LiDAR Quality Assessment Report

SD_Missouri River Lidar Dewberry_2016_D16 - Block 4

NGTOC
2018-06-13
Sarah Klaas

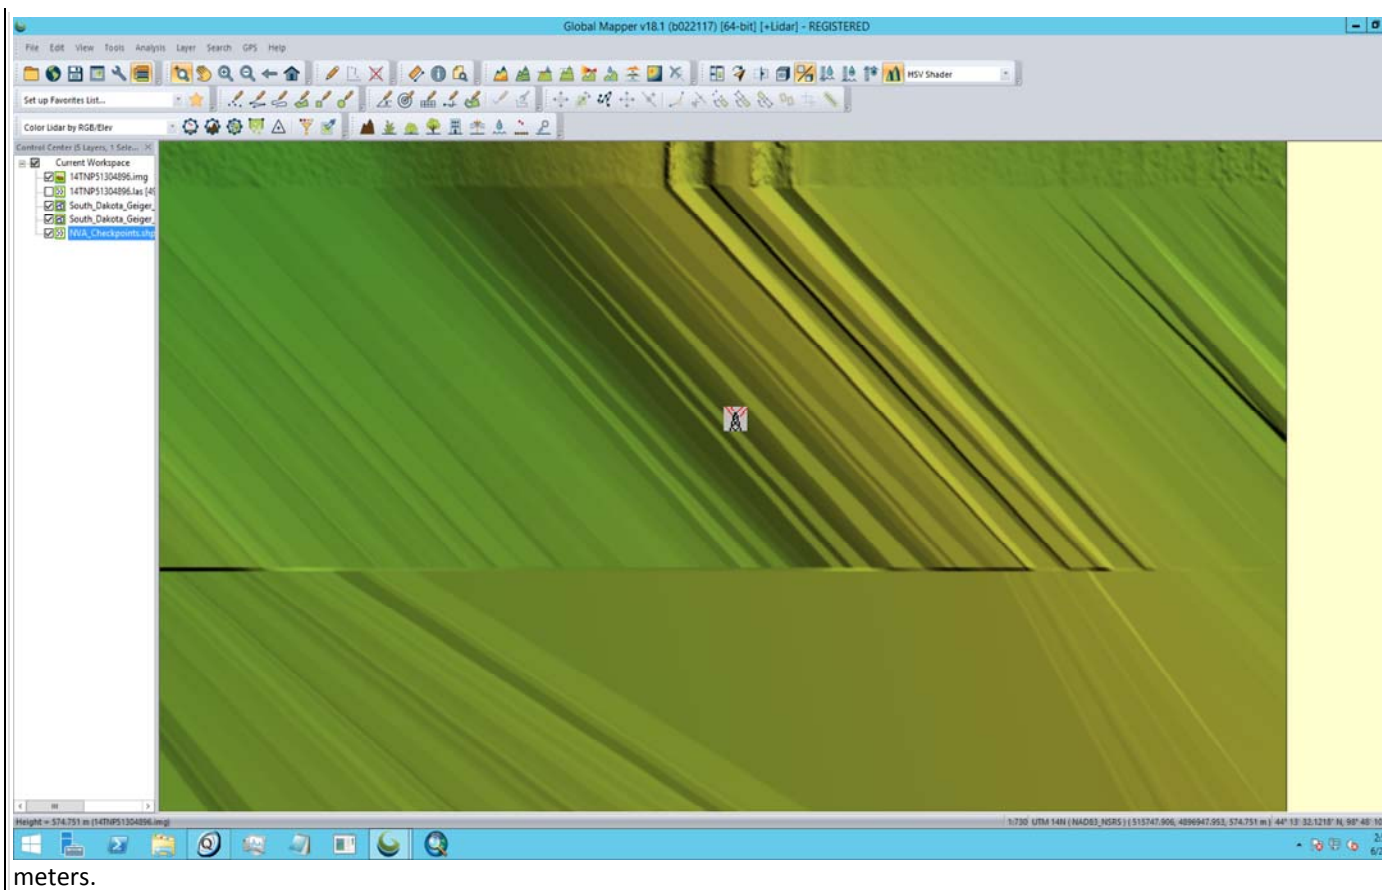
VVA testing failed to meet USGS specifications. Three of the worst points are pictured below, showing the checkpoint below the ground surface.

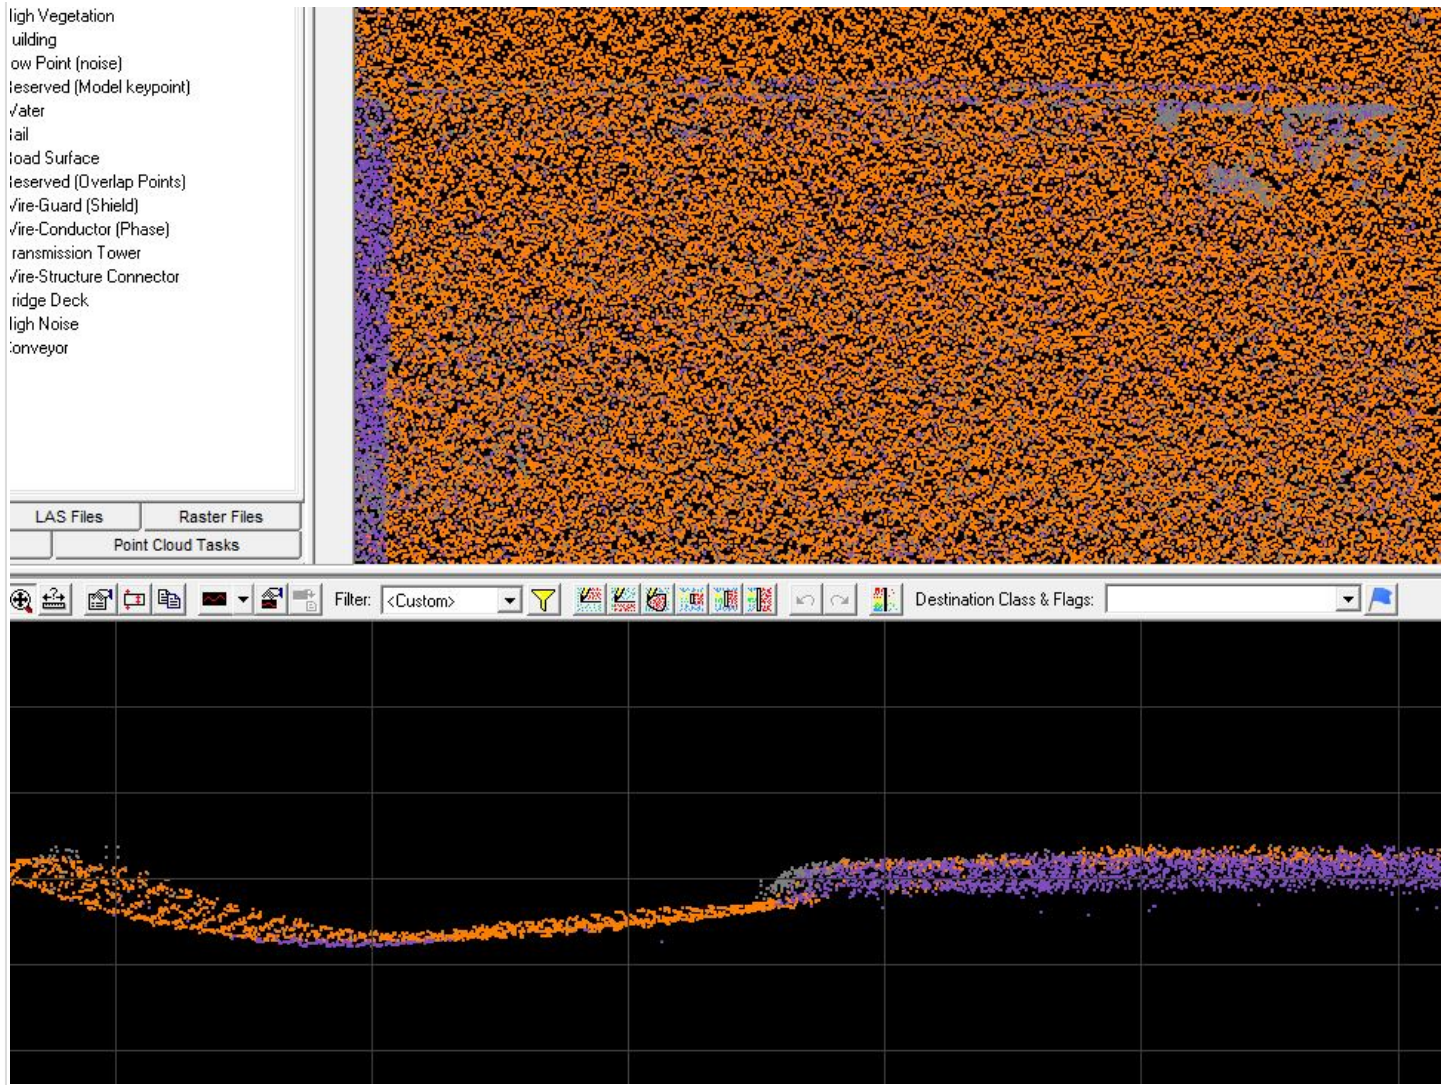
Possible classification issue: ground and low noise points in areas where there could be vegetation in fields. It is not certain that the ground points are actual ground. (6/13/2018)

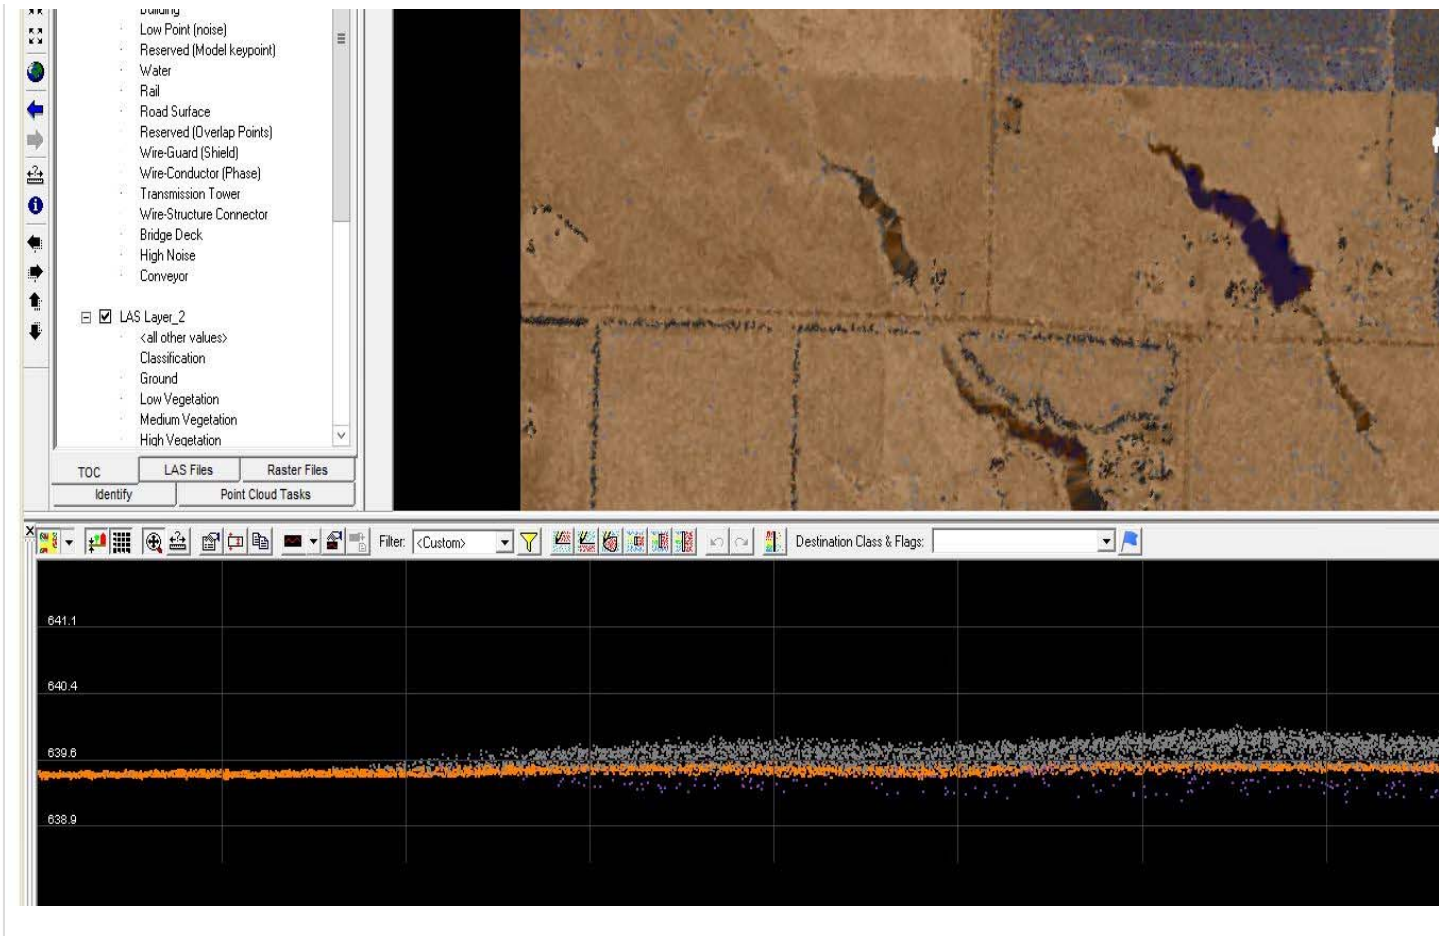
Example of a similar area in another block where the classification of the ground points looks correct.

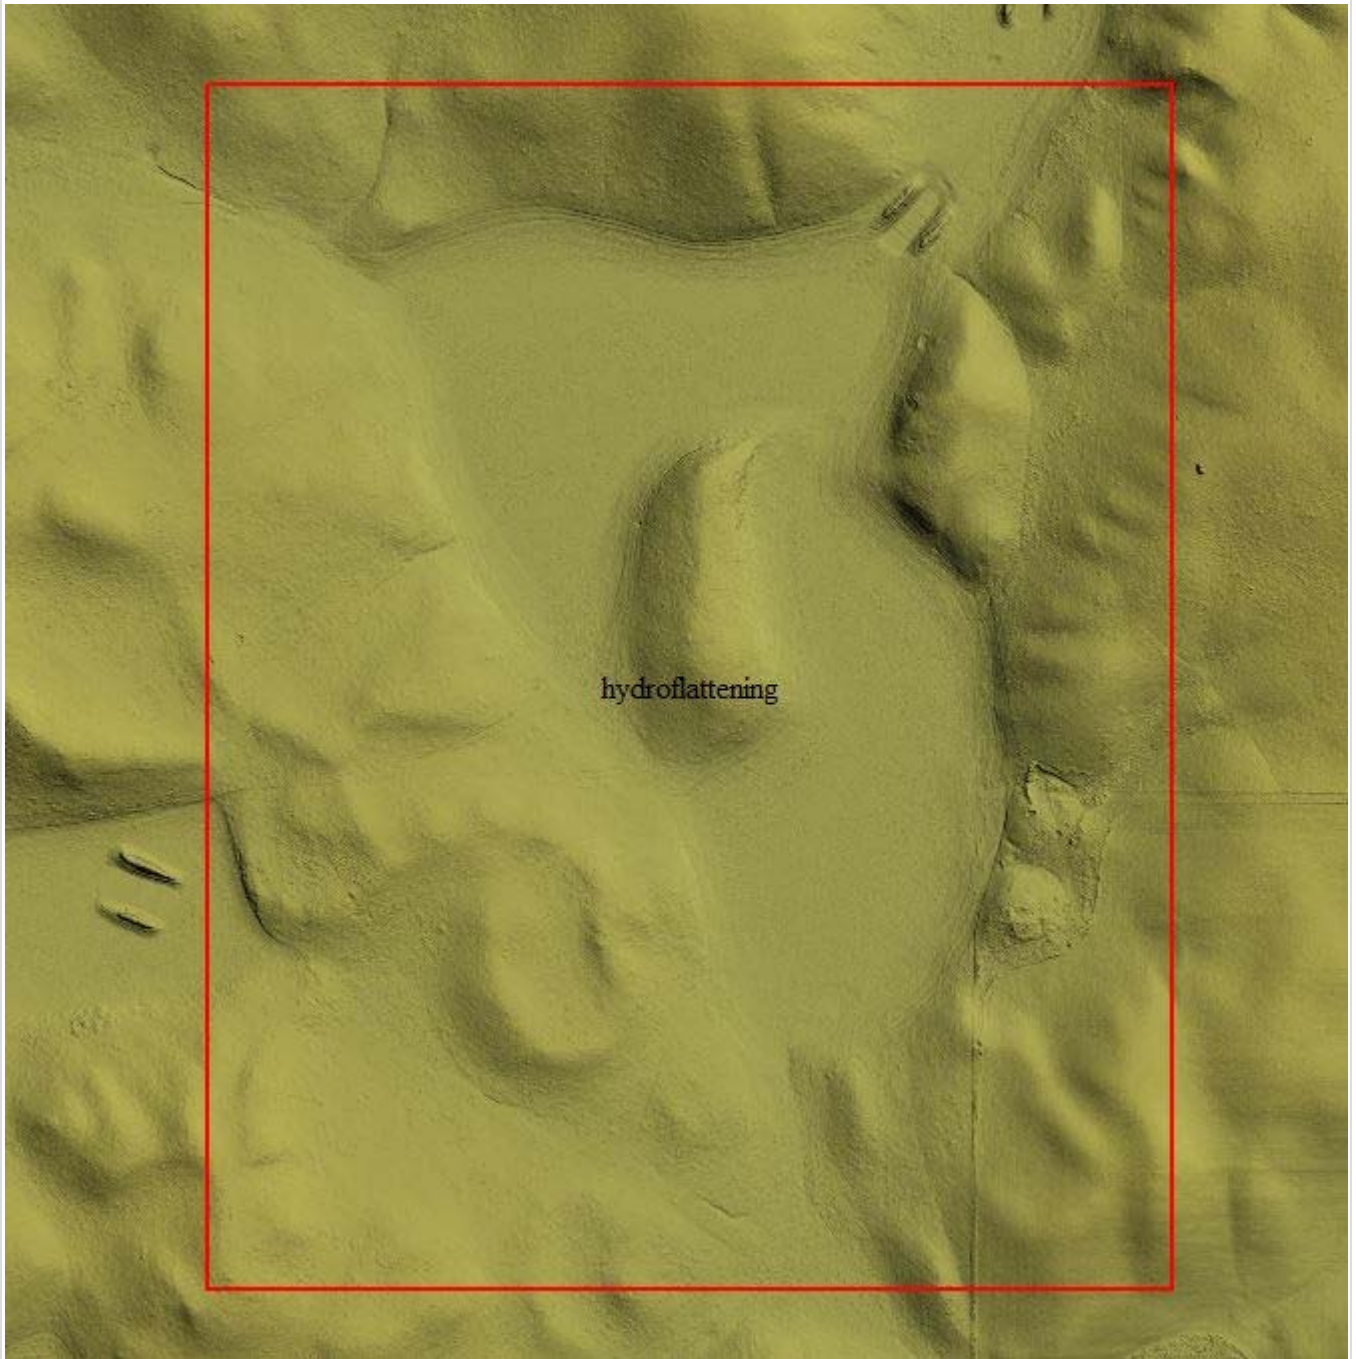
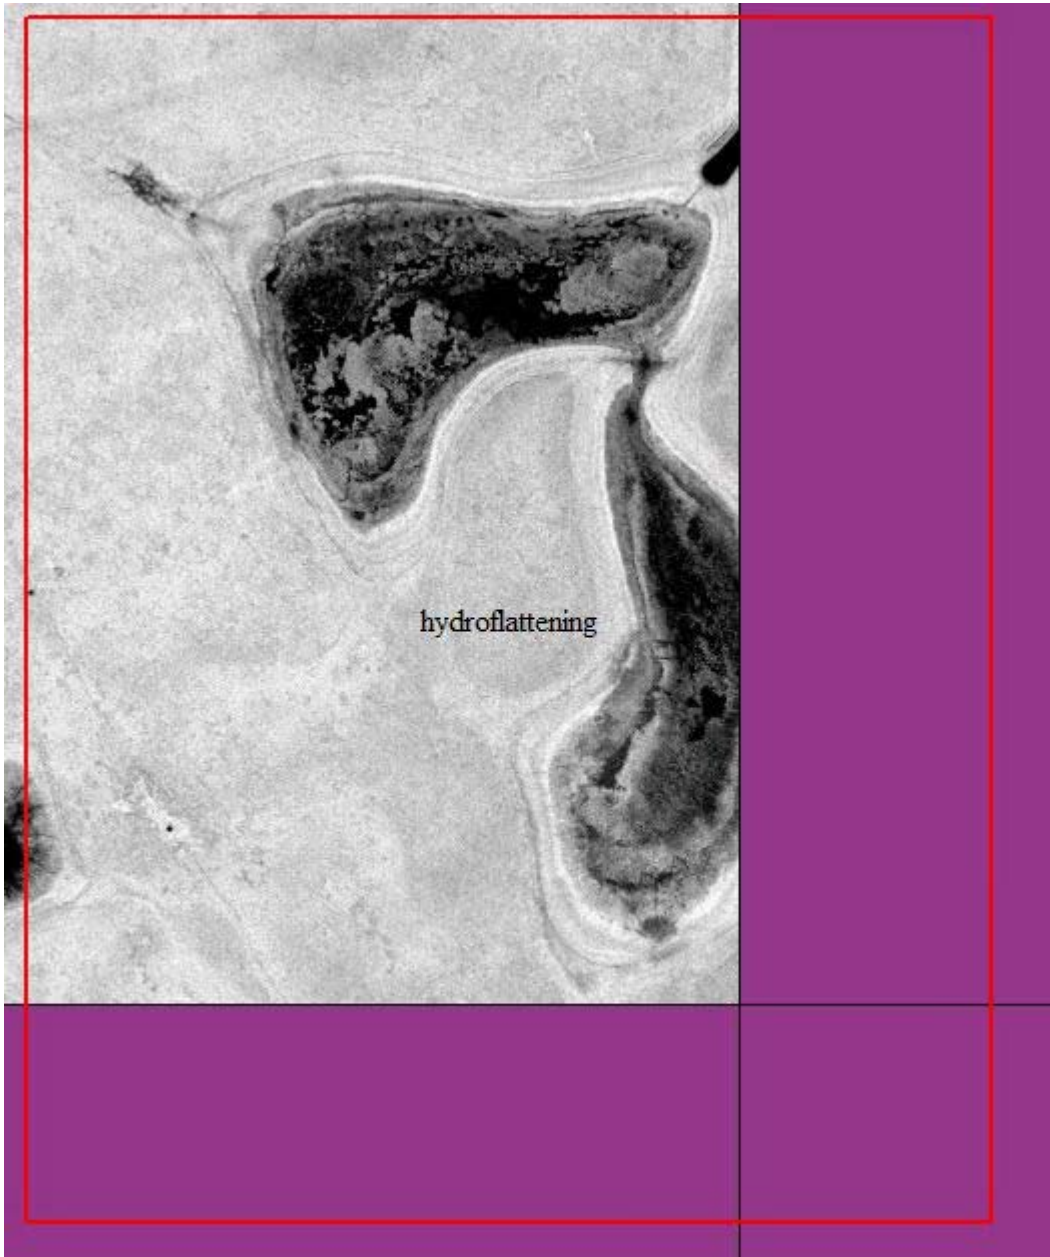
7 hydroflattening errors were found in block 4, waterbodies greater than 2 acres are not hydroflattened. Examples of this type of error can be seen below. (6/13/18)
